# ADDENDUM

NO. 1

**PROJECT NAME:** Fielder Road Modular Site

## ARCHITECTURAL ITEMS FOR ADDENDUM NO. 1

LANDSCAPE DETAILS  
SHEET NUMBER  
L3.01

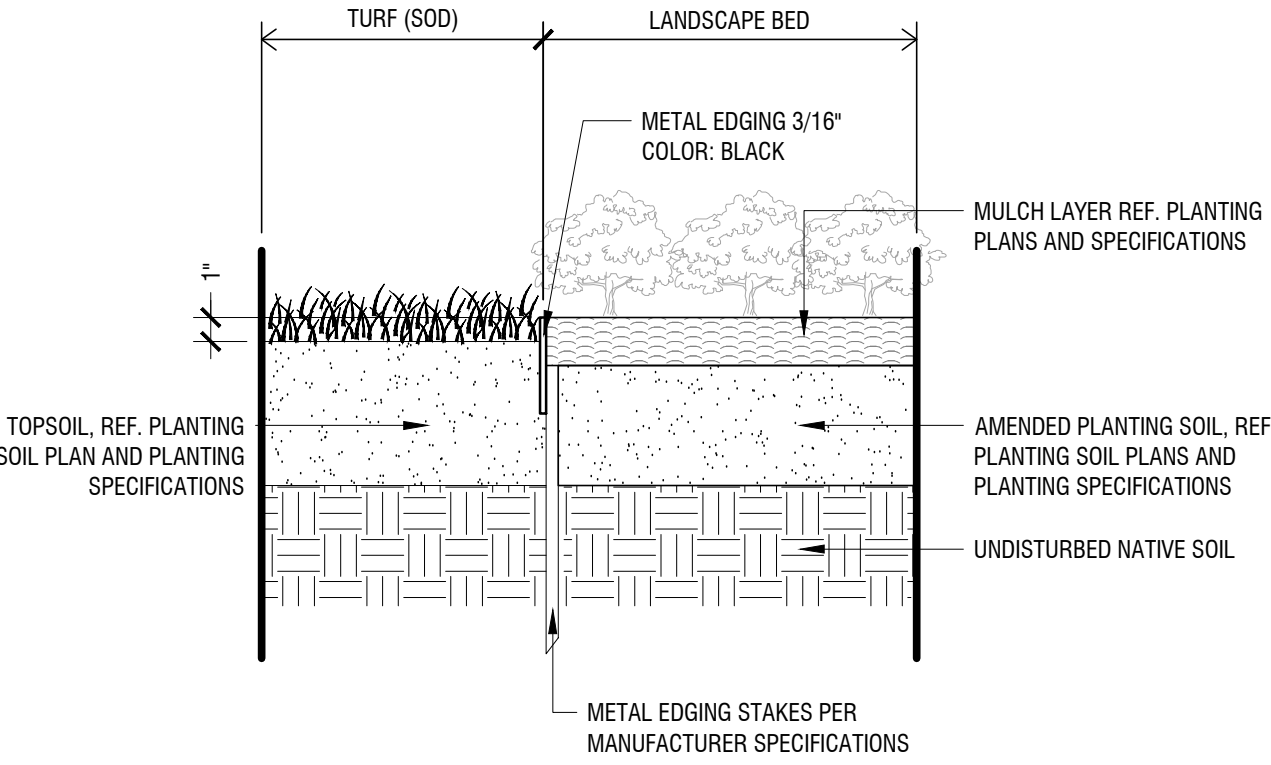
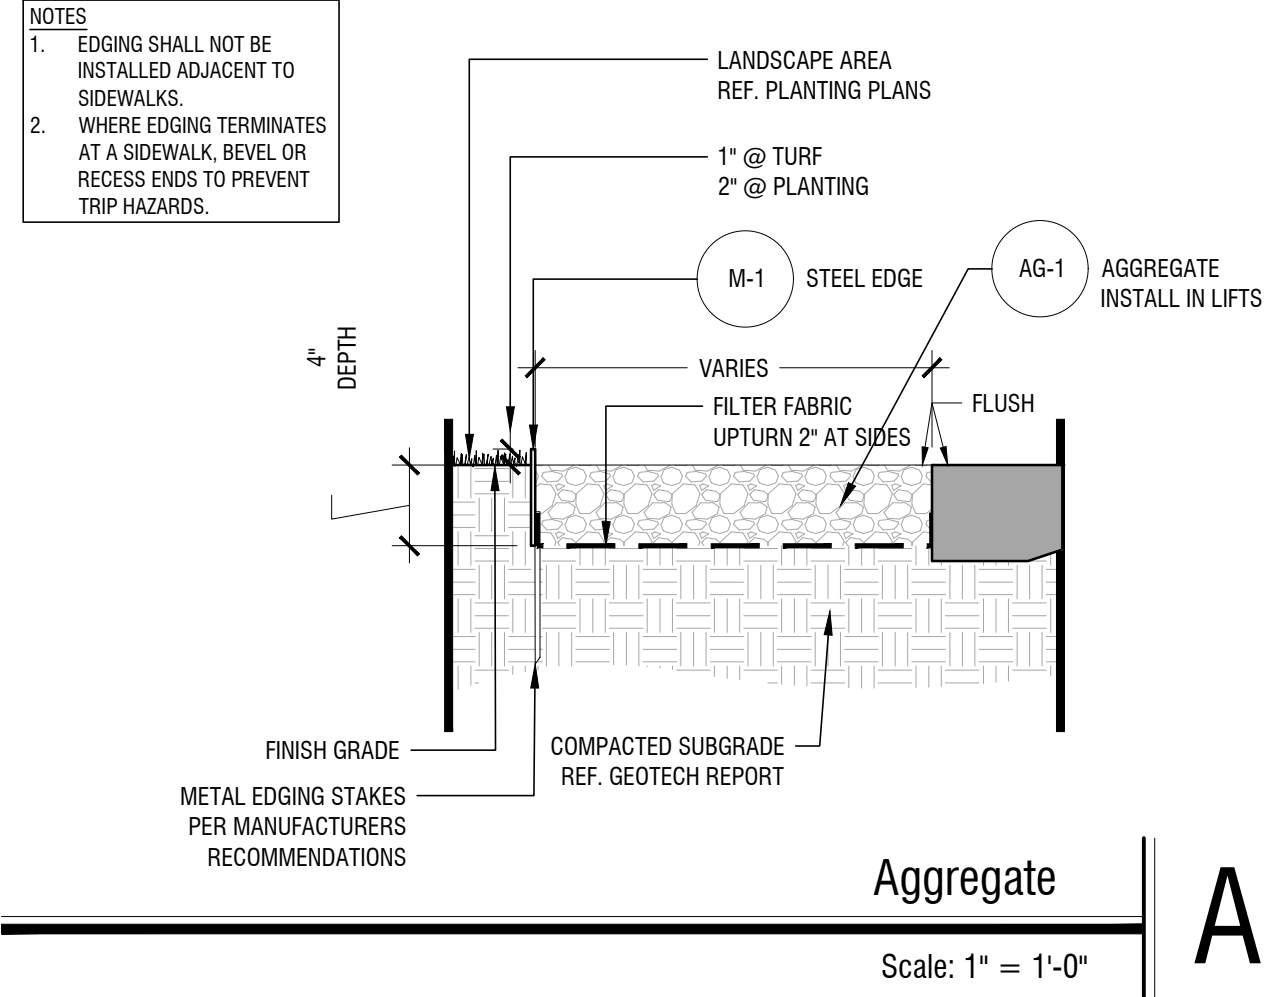
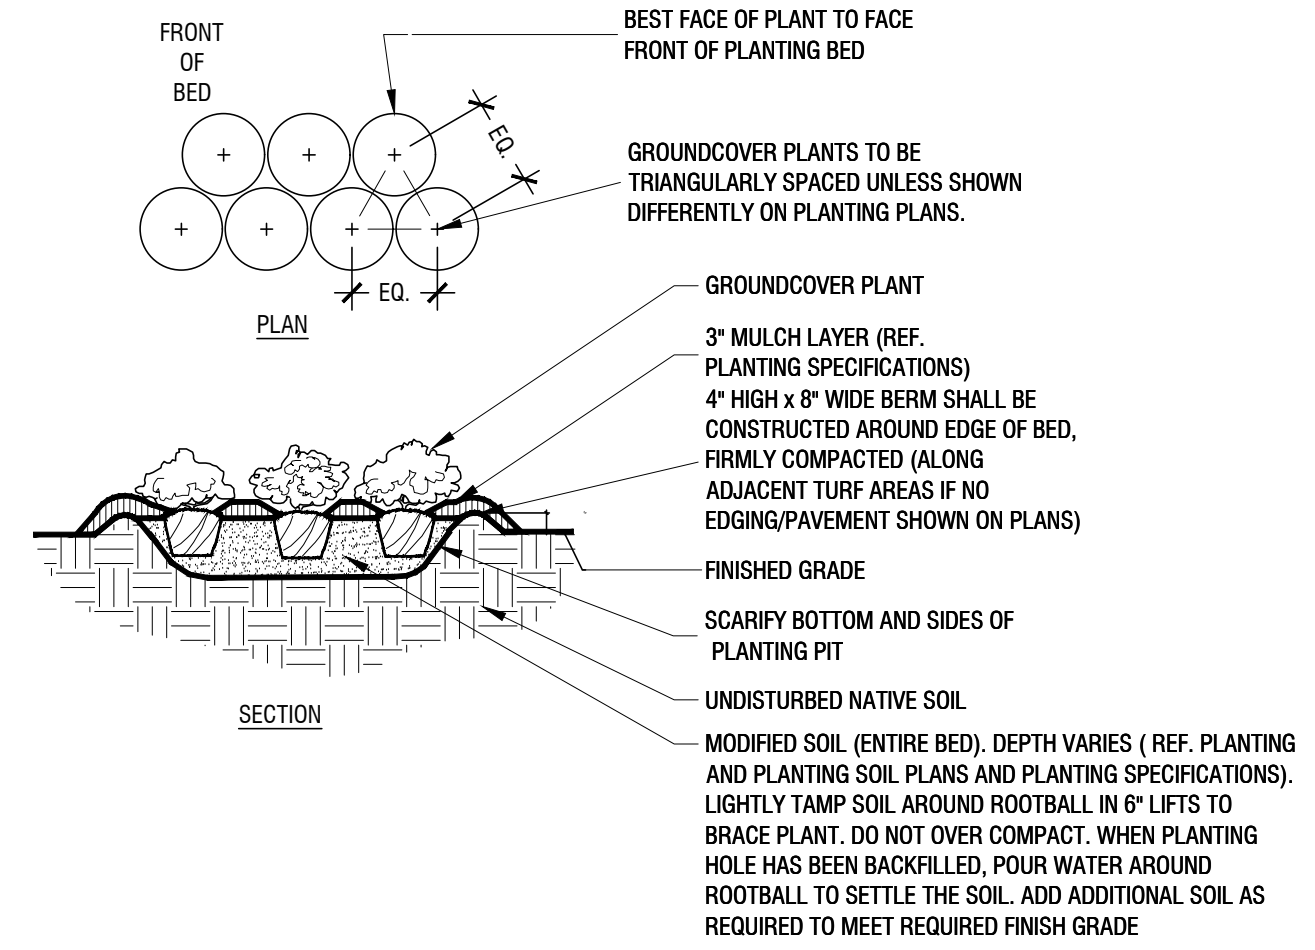
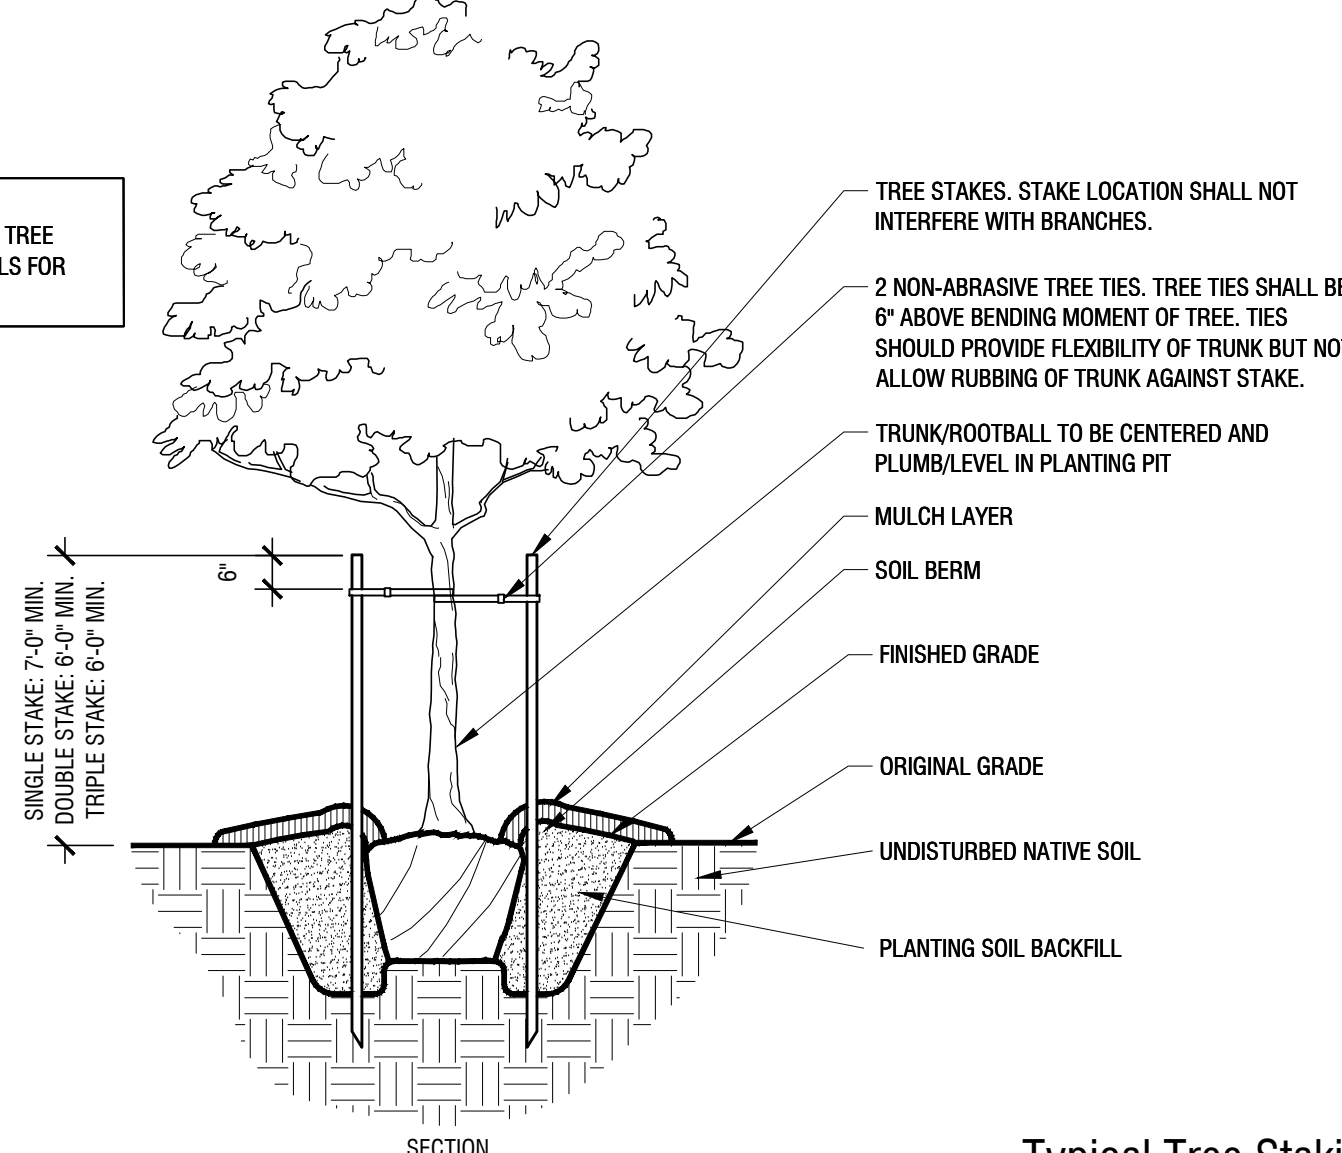
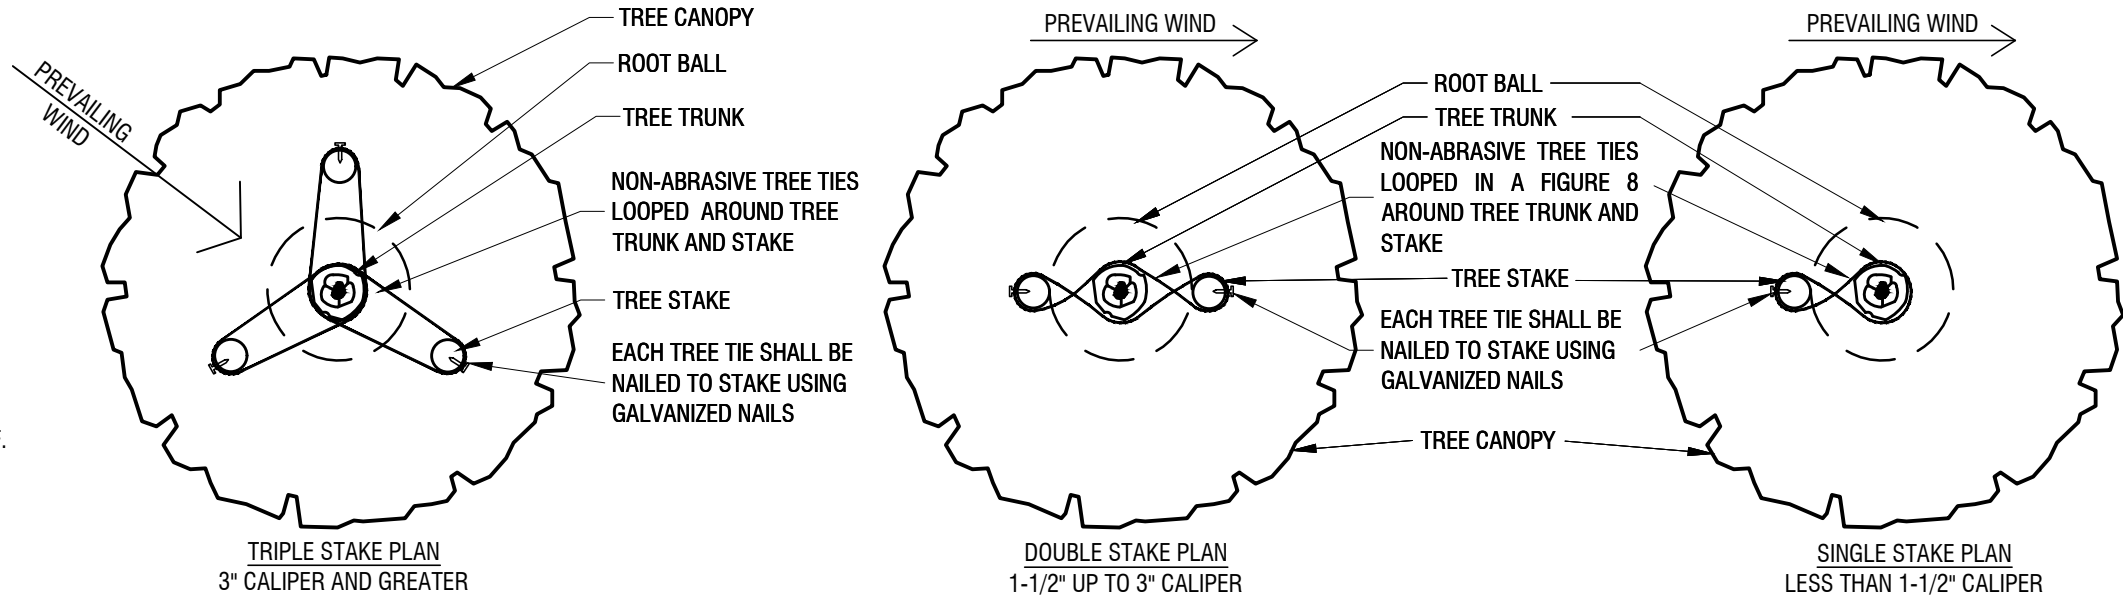
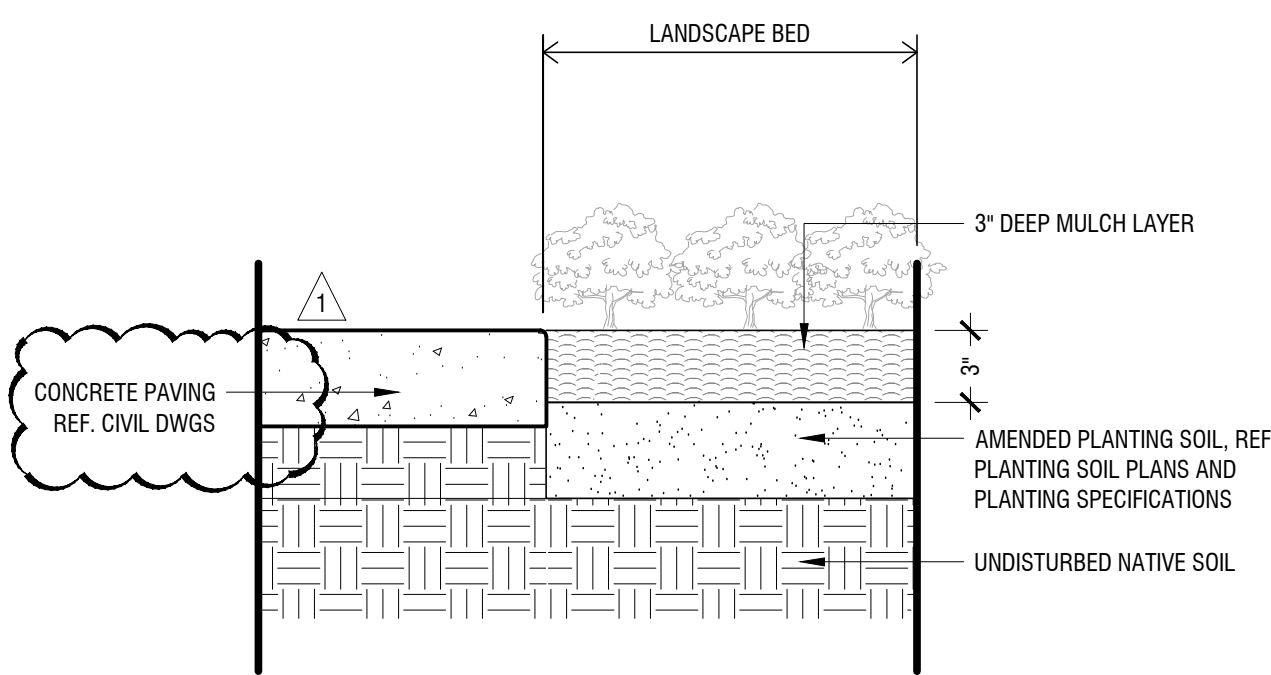
#### AD No 1, Landscape Item 3: To the Drawings, Sheet L3.01

- 1) Updated detail H to clarify the concrete paving to be by civil.

SHEET NUMBER  
L3.03

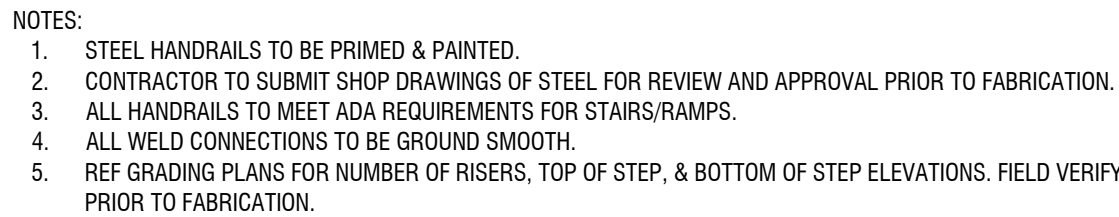
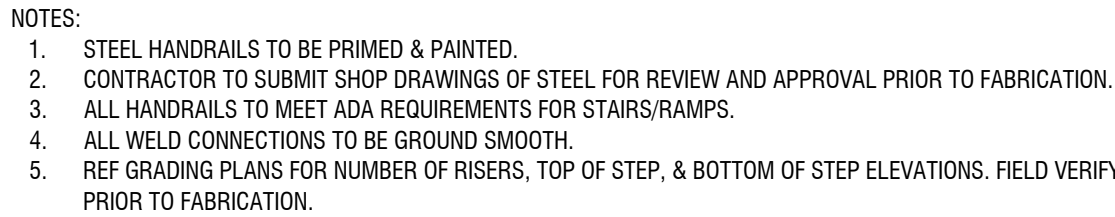
#### AD No 1, Landscape Item 5: To the Drawings, Sheet L3.03

- 1) Added sheet for ramp, handrail and guardrail details.

SHEET NUMBER  
L3.04

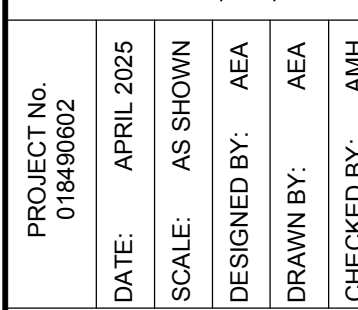
#### AD No 1, Landscape Item 5: To the Drawings, Sheet L3.04

- 1) Added sheet for retaining walls, cheek wall and ramp handrail.
